[Docket No. FAA-2020-0442; Project Identifier AD-2020-00260-E; Amendment 39-21640; AD 2021-14-13]

Airworthiness Directives; Pratt & Whitney Turbofan Engines

ACTION: Final rule.

Figure 1 to Paragraph (g)(1)(iii) – Crack Inspection Critical Areas

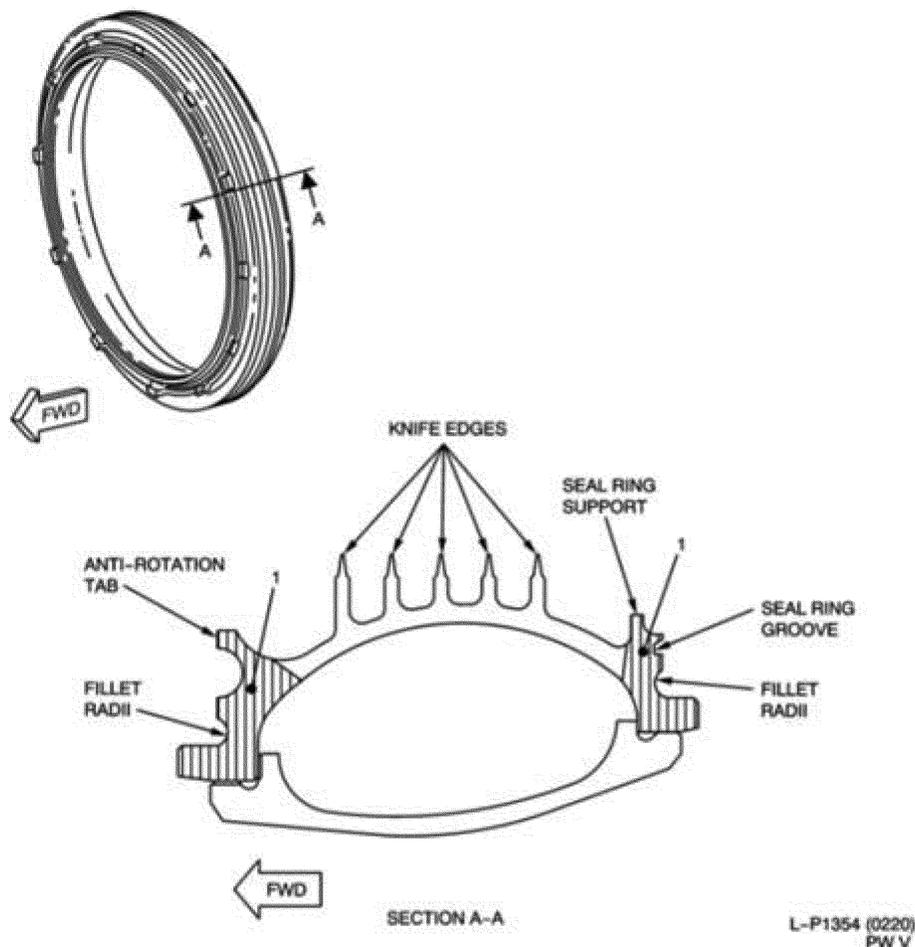
Delta and MTU requested that the FAA clarify the location of the forward and aft edges of the HPT 2nd-stage air seal assembly. Delta asked if the forward edge is the barrel section forward of the #1 knife-edge or any part that extends beyond the barrel section.

Delta and FedEx requested that the FAA clarify the definition of "through-crack." Delta asked if a "through-crack" is a crack going through the axial direction or radial direction of the HPT 2nd-stage air seal assembly. Delta referenced Figure 5 of NDIP-1217 that appears to show a through-crack in the axial direction. Delta inferred from paragraph (i)(4) of the NPRM that a through-crack is in the radial direction. Delta requested a diagram to help illustrate what constitutes a through-crack.

The FAA removed references to "forward edge" and "aft edge" of the HPT 2nd-stage air seal assembly from this AD. In their place, the FAA added Figure 1 to paragraph (g)(1)(iii) of this AD to specify the locations of the HPT 2nd-stage air seal assembly that require inspection for cracks.

The FAA agrees that it is difficult to differentiate between a surface crack and through-crack; therefore, the FAA removed references to “through-crack” from this AD. The FAA notes that any crack, in any direction, found in the HPT 2nd-stage air seal assembly, requires removal of the HPT 2nd-stage air seal assembly from service. As stated in an earlier response, the FAA added Figure 1 to show the locations of the HPT 2nd-stage air seal assembly that require inspection for cracks. However, the FAA is not providing dimensions that bind the areas. If the inspections of the HPT 2nd-stage air seal assembly reveal a crack in the shaded regions of Figure 1, which extends towards the knife-edge region, the HPT 2nd-stage air seal assembly must be removed from service.

(iii) During the visual inspection or FPI required by paragraph (g)(1)(i) of this AD, if a crack is found in the shaded regions of the HPT 2nd-stage air seal assembly identified in Figure 1 to paragraph (g)(1)(iii) of this AD (Figure 1), which extends towards the knife-
